**ADDENDUM NUMBER THREE (3)
TO THE PLANS AND SPECIFICATIONS FOR:**

July 3, 2019

**LRGV DC
BUILDING 'D' EXPANSION
Project No. 18.45**

Sheet Title:
WALL
SECTIONS

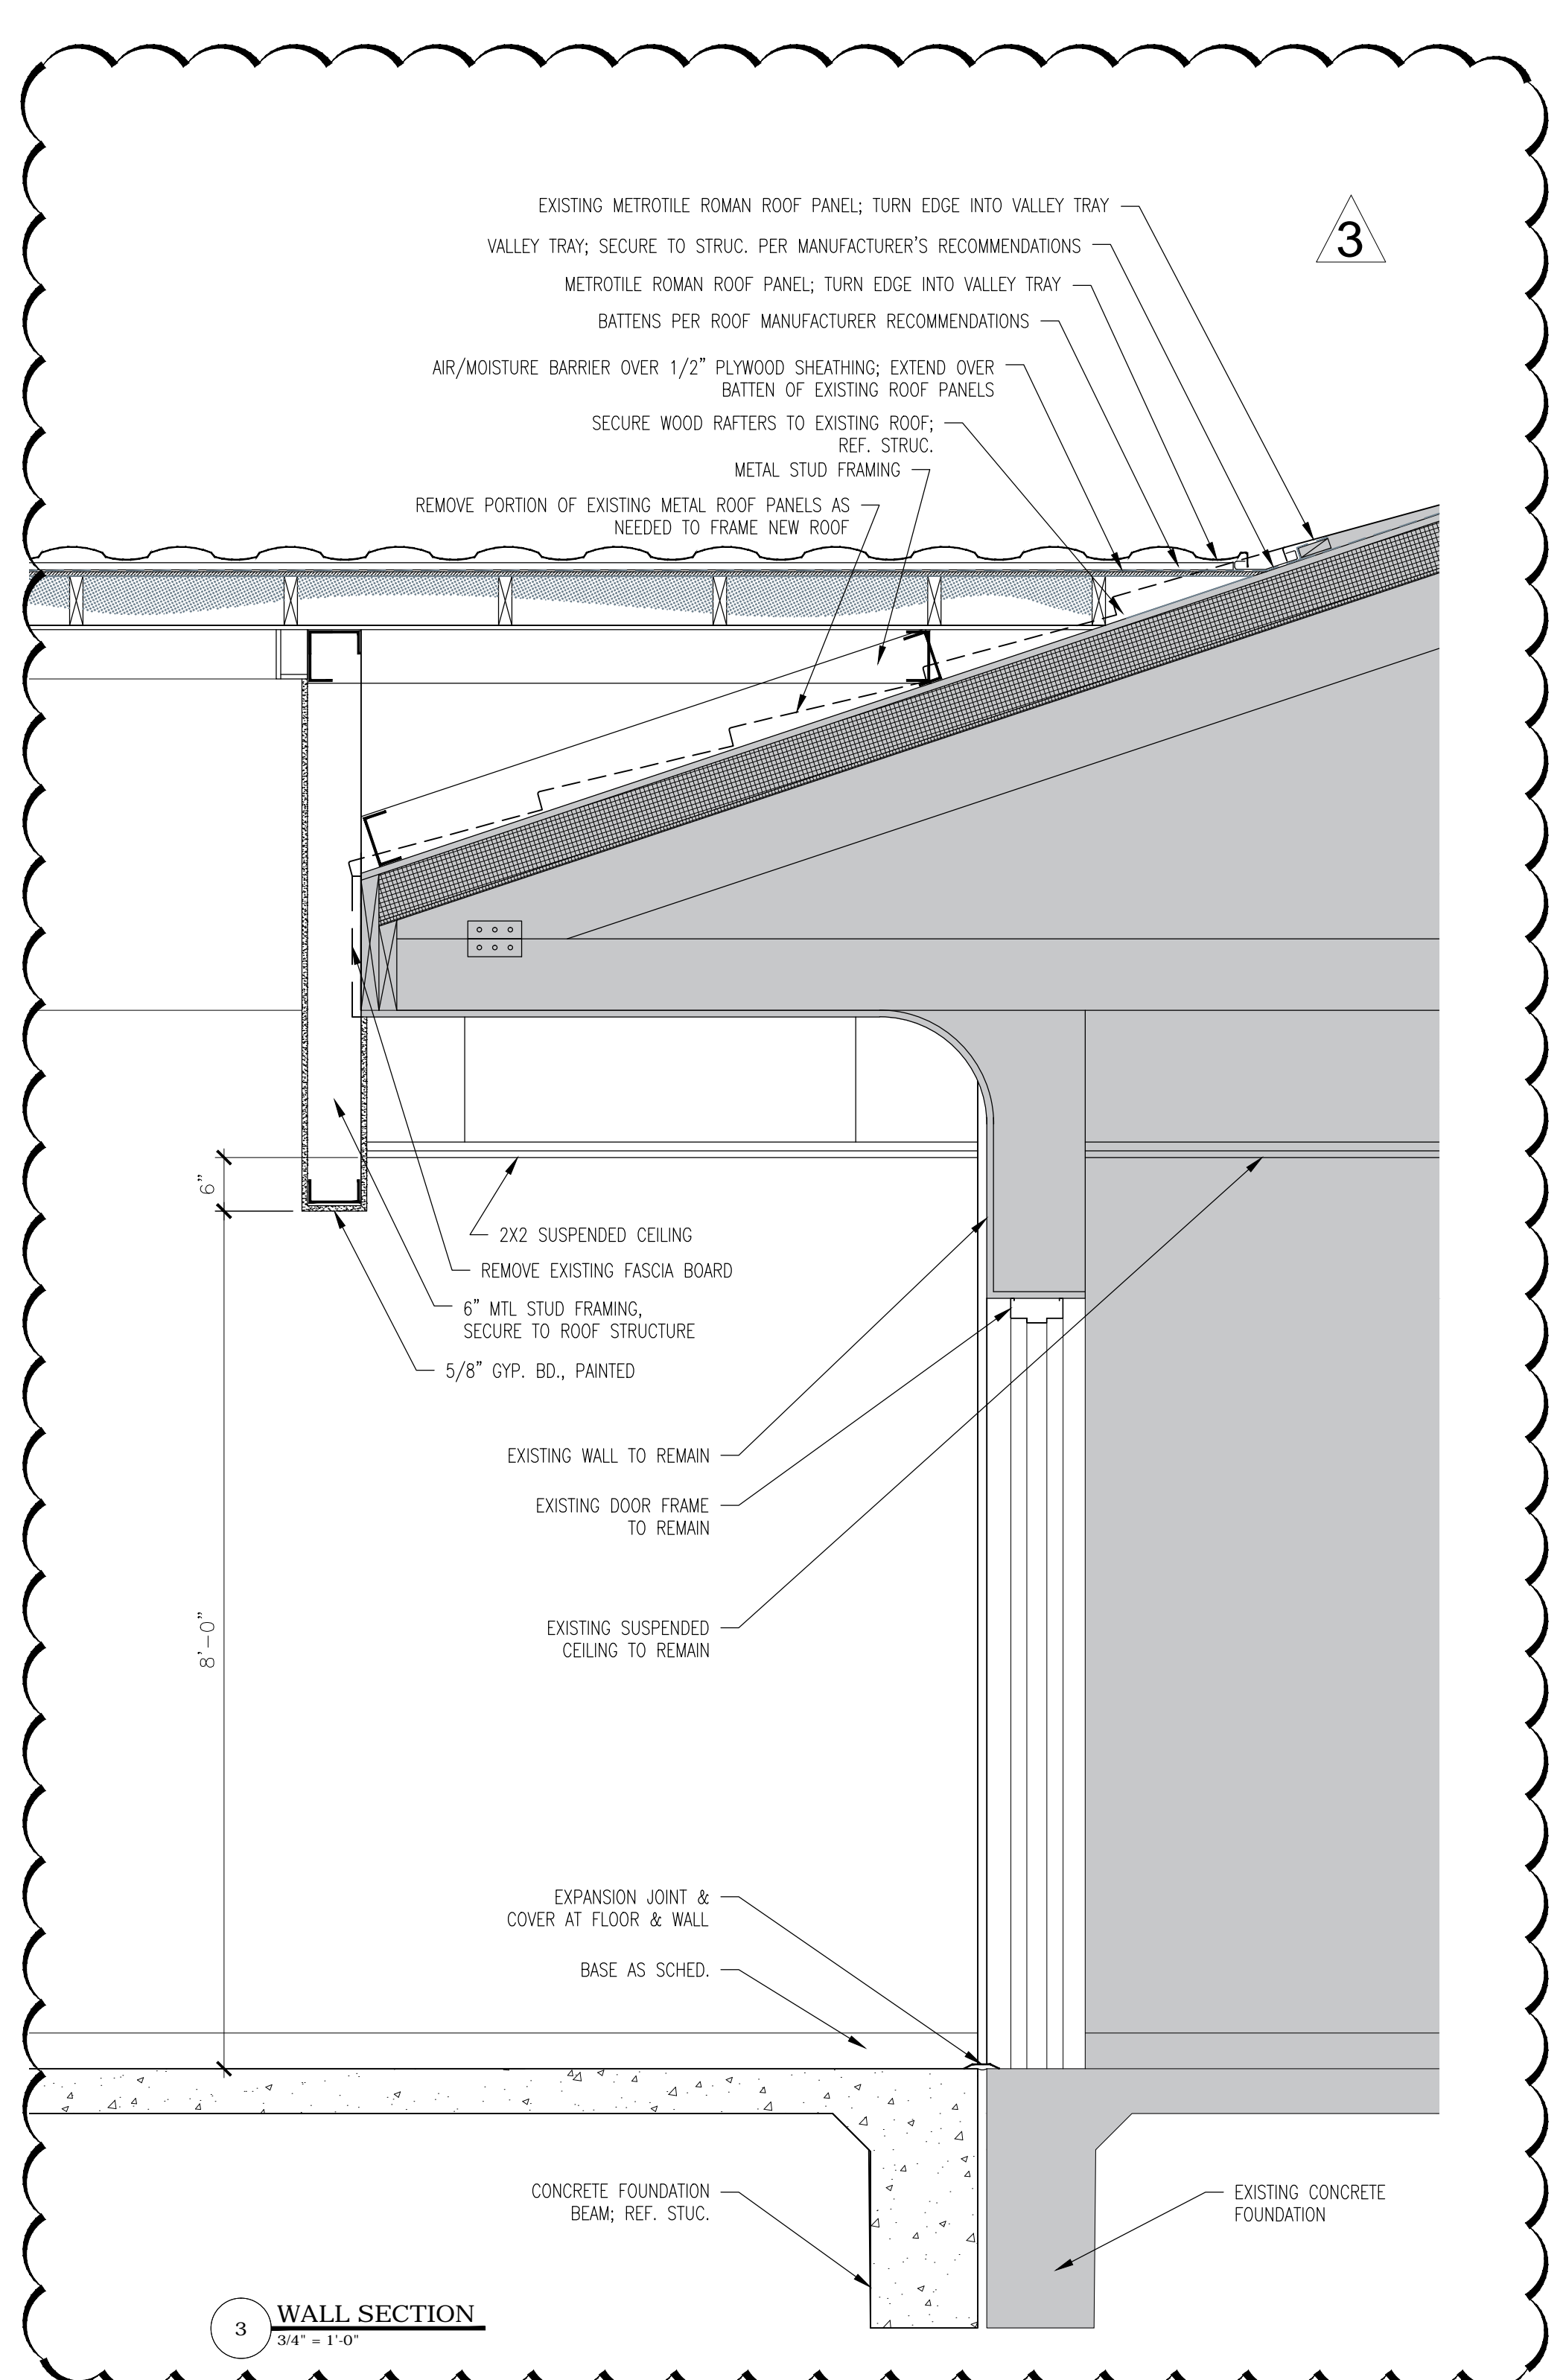
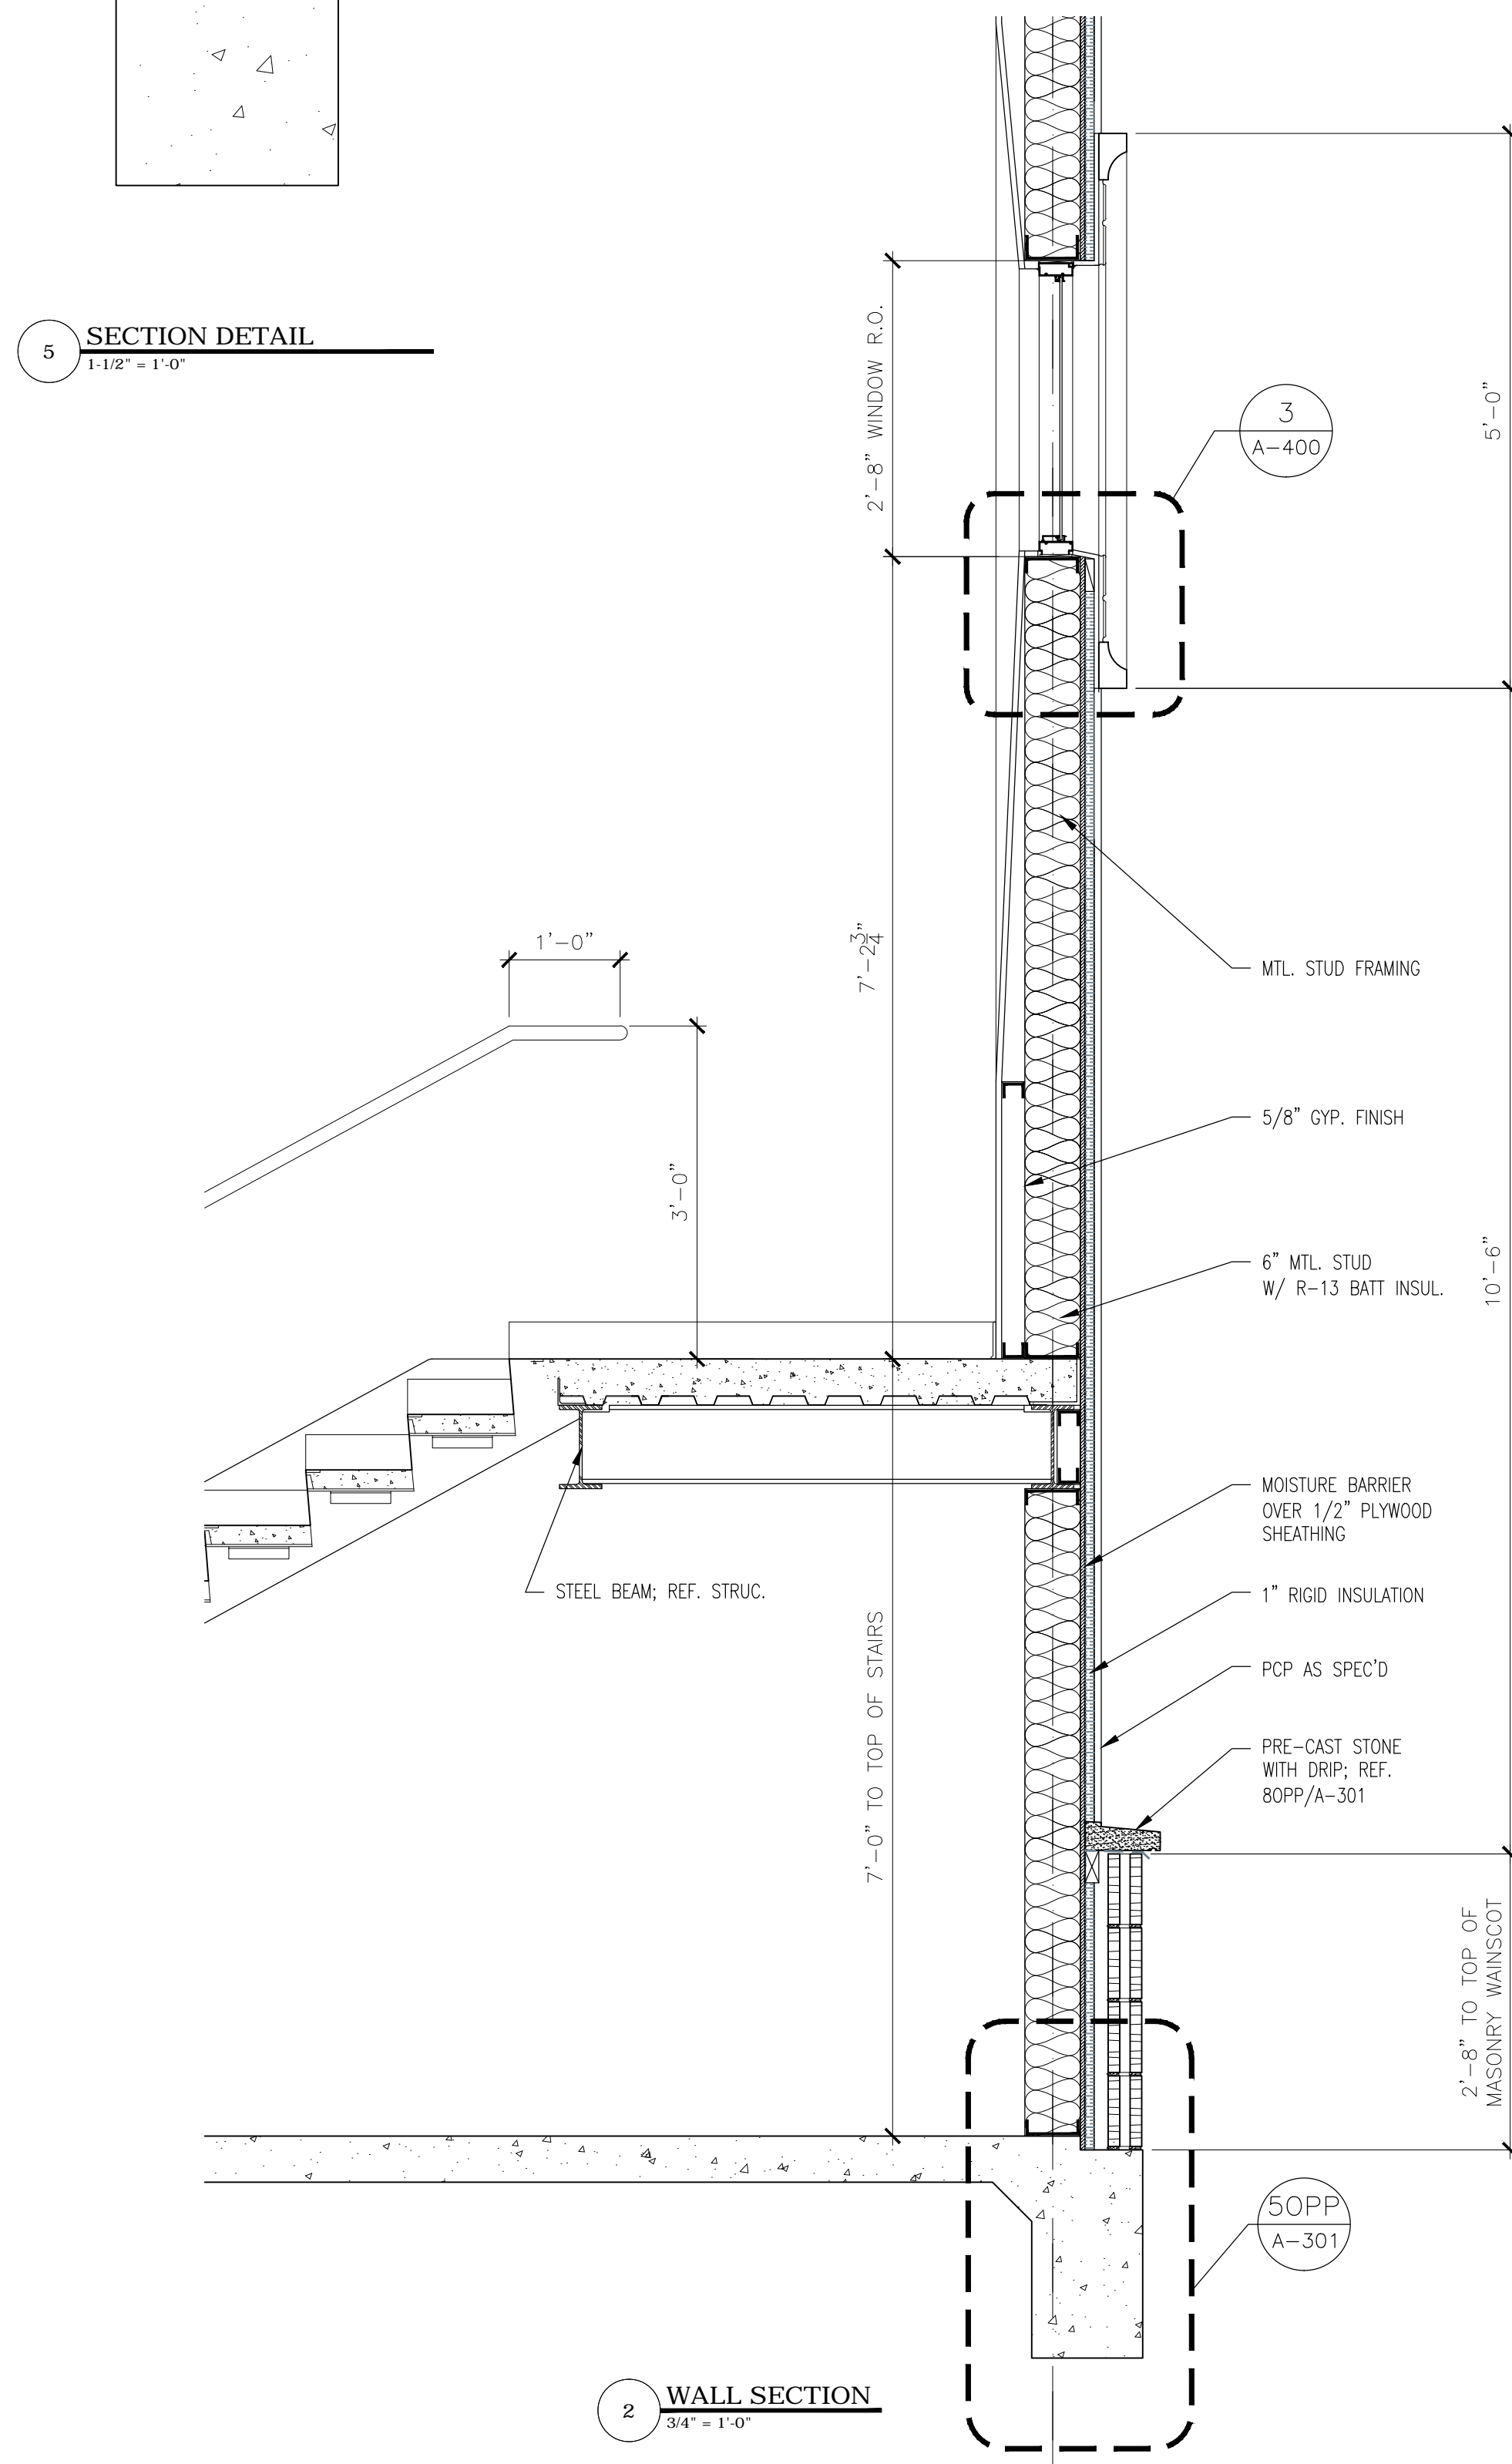
Sheet A-301 Wall Sections

Sheet A-301 Wall Sections in this Addendum shall replace the previously-issued Sheet A-301.
